ADDENDUM NO. 1

ISSUE DATE: April 4, 2018

CRC College Center Expansion

LRCCD BID NO. 17021

SHEET NO:
A3.34

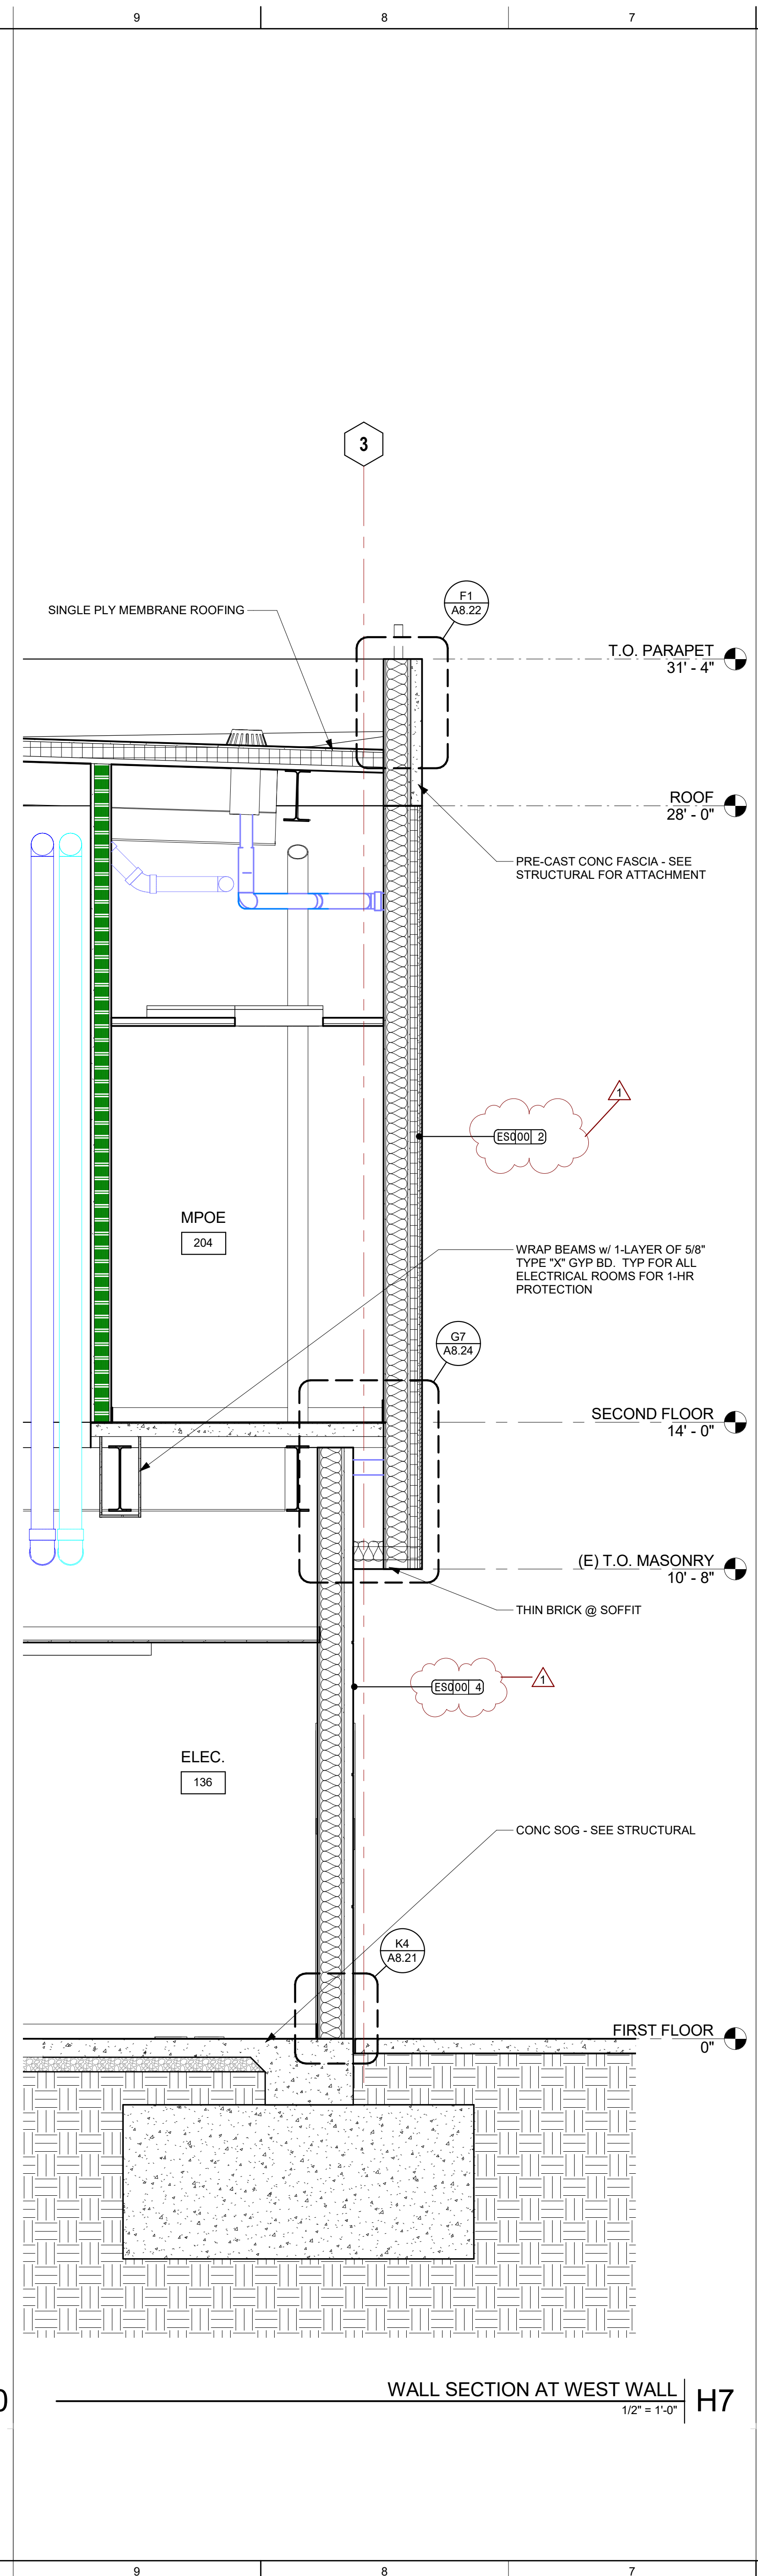
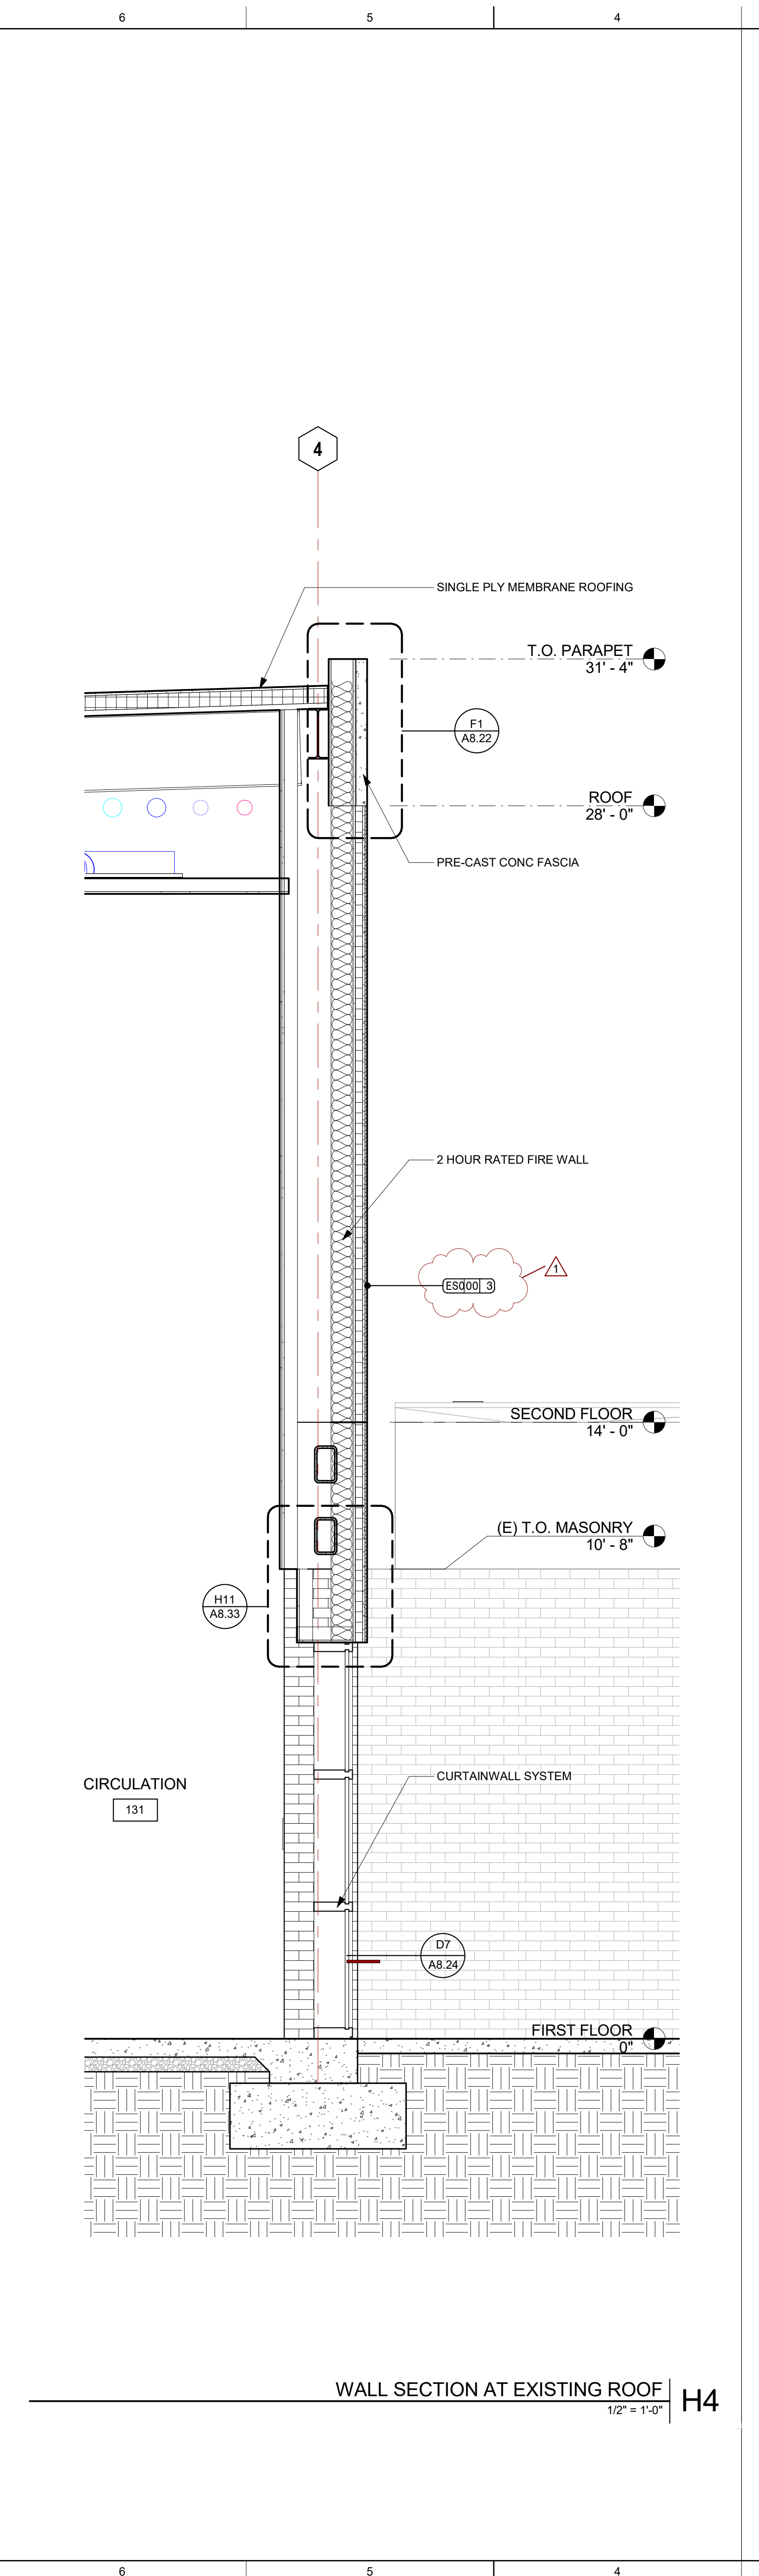
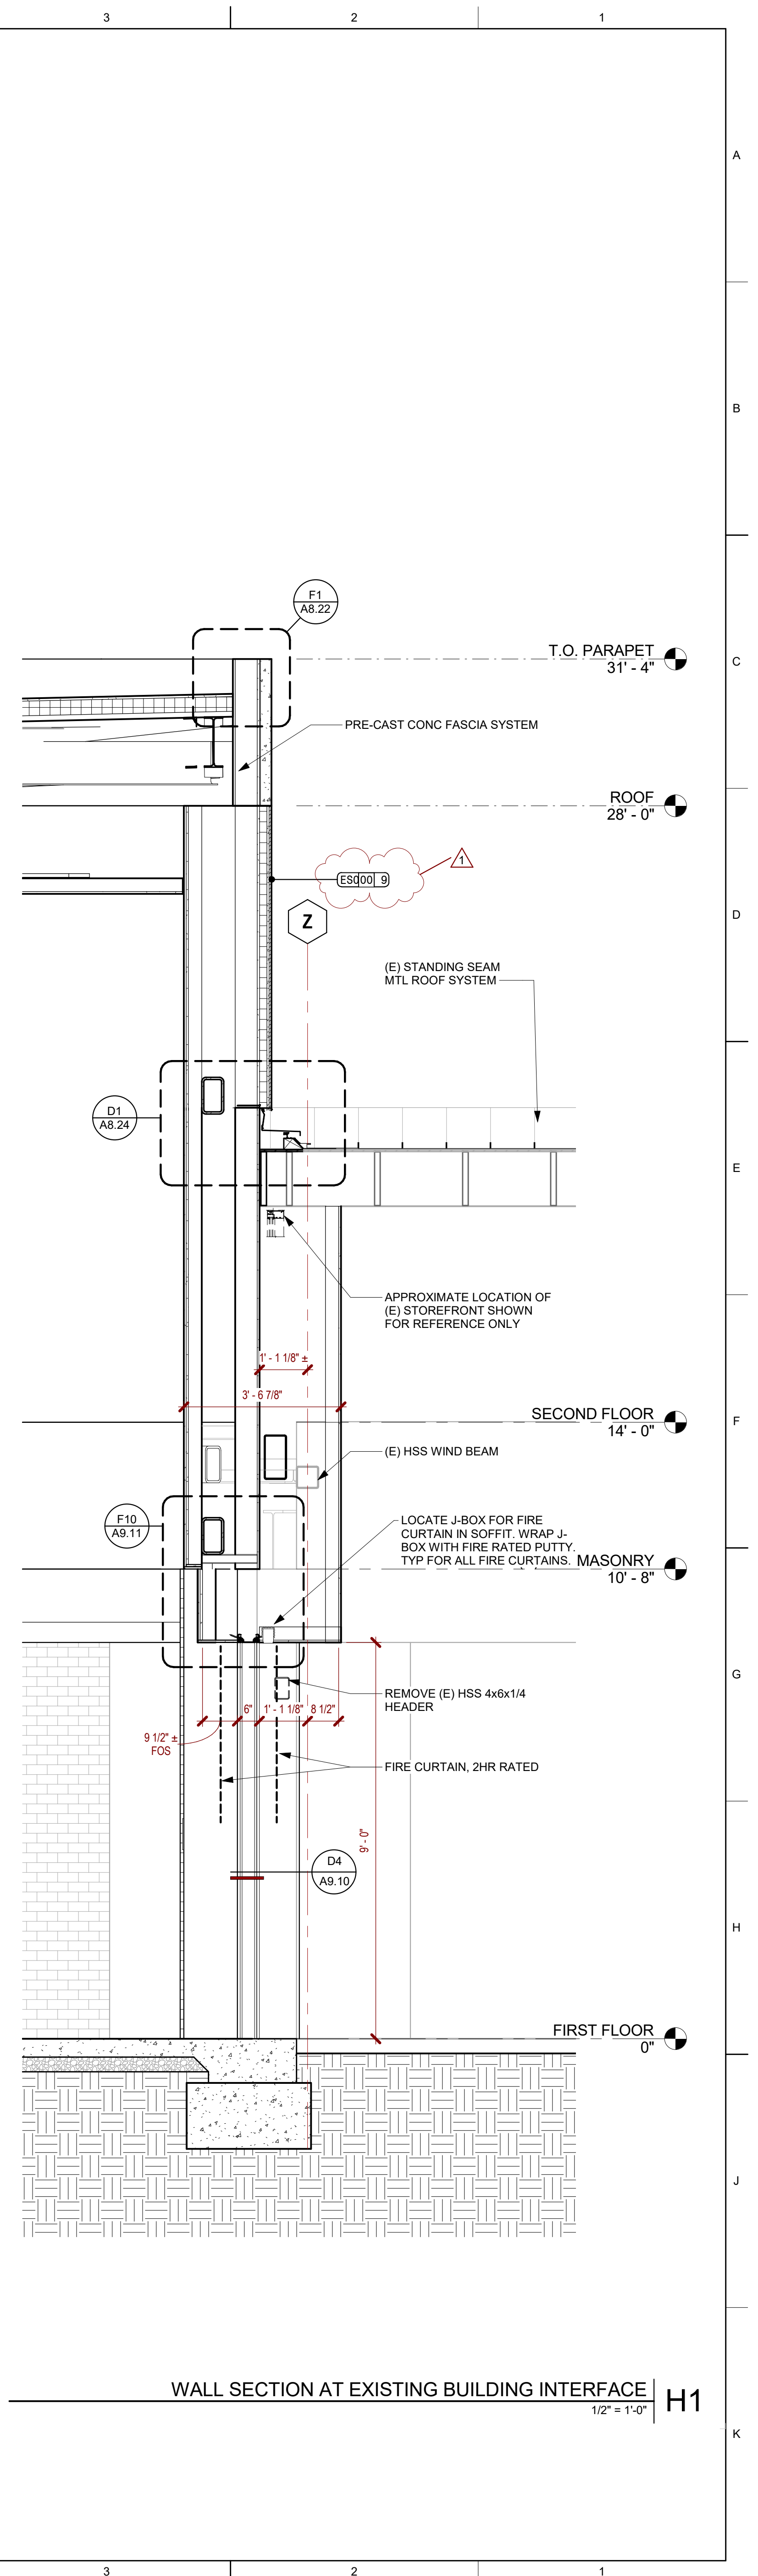
- A3.31 – Modified wall assembly notes
- A3.32 – Modified wall assembly notes
- A3.33 – Modified wall assembly notes
- A3.34 – Modified wall assembly notes
